Product Change Notification

Date Issued :	October 14, 2026	**PCN Number :**	518872
Reason for Change :	Change to Product		
Description of Change :	Correction of a typo in the SD. This change does not affect product design, dimensions, fit, form, function, reliability, or performance.		
Assessment of Change :	No change to parts - Form/Fit/Function		
Planned Implementation Date :	April 16, 2027		
Customer Sample Availability Date:	October 16, 2026

【Change Overview】

Correction of a typo only in the recommended P.W. board pattern layout in the SD. This change does NOT affect the actual product's design, dimensions, fit, form, function, reliability, or performance.

RECOMMENDED P.W.BOARD PATTERN LAYOUT (REFERENCE)
(SM OPENING DIMENSION)

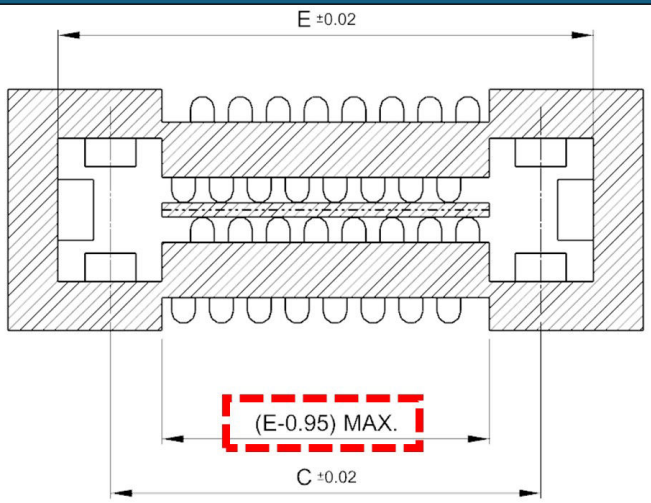
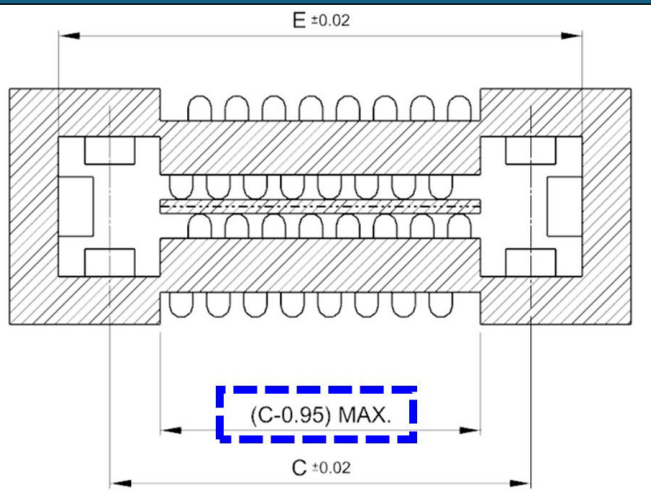
Before "(E-0.95)MAX." is incorrect dimension	After "(C-0.95)MAX." is correct dimension
